Office Action Summary

10/721,857

BURBANK ET AL.

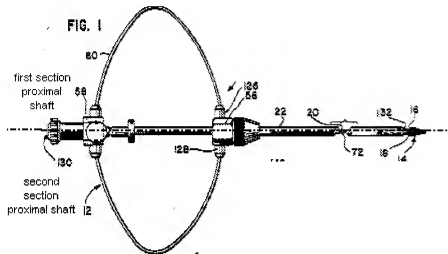
shaft section to a second position further away from the first operative proximal shaft section (C4:L45-65); and a second occluding member having a second elongated shaft (18), a second operative proximal shaft section configured to extend out of the patient during treatment (see below) and a second distal shaft section (34) with a second pressure applying occluding element (30) secured to the second distal shaft section, wherein the second occluding member has a second mechanism (other of spring 60) to distally extend at least part of the second pressure applying occluding element from a first position closer to the second operative proximal shaft section to a second position further away from the second operative proximal shaft section; and a connection (at core 72) between the first and second occluding members which is configured to adjust spacing the first and second pressure applying occluding elements (core 72 is pushed distally, pushing occluding members distally, thereby adjusting spacing (C4:L45-65)) so that it is *capable of* pressing the pressure applying occluding elements against the patient's vaginal wall to occlude underlying uterine arteries, wherein the first pressure applying occluding element is pivotally connected (at pin 40) to the distal shaft section of the first occluding member and the first occluding member includes a third mechanism (112, C5:L46-63) for selectively rotating the first pressure applying occluding element relative to the distal shaft section of the first occluding member.

6. Regarding claim 34: Hasson discloses an intravaginal device *capable of* occluding uterine arteries comprising: a first occluding member having a first elongated shaft (16) with a proximal end and a distal end, a first occluding element (28) secured to the distal end (32) of the first elongated shaft, the first occluding element having a first

pressure applying surface (36) at a distal end thereof, and a first extending actuator (one of spring 60) coupled with the first occluding element for selectively moving the first pressure applying surface distally away from the distal end of the first elongated shaft (C4:L45-65), wherein the first occluding element is pivotally connected (44) with the distal end of the first elongated shaft and the device further comprises a rotating actuator (112) coupled with the first occluding element for selectively rotating the first pressure applying surface through a range of angles relative to the first elongated shaft (C5:L46-63); and a second occluding member having a second elongated shaft (18) with a proximal end and a distal end (34), a second occluding element (30) secured to the distal end of the second elongated shaft, the second occluding element having a second pressure applying surface (38) at a distal end thereof; and the first and second occluding members being coupled together (via rod 72) for selectively adjusting spacing between the first and second pressure applying surfaces (core 72 is pushed distally, pushing occluding members distally, thereby adjusting spacing (C4:L45-65)). As to claim 37: The second occluding member further comprises a second extending actuator (other of spring 60) coupled with the second occluding element for selectively moving the second pressure applying surface distally away from the proximal end of the second elongated shaft.
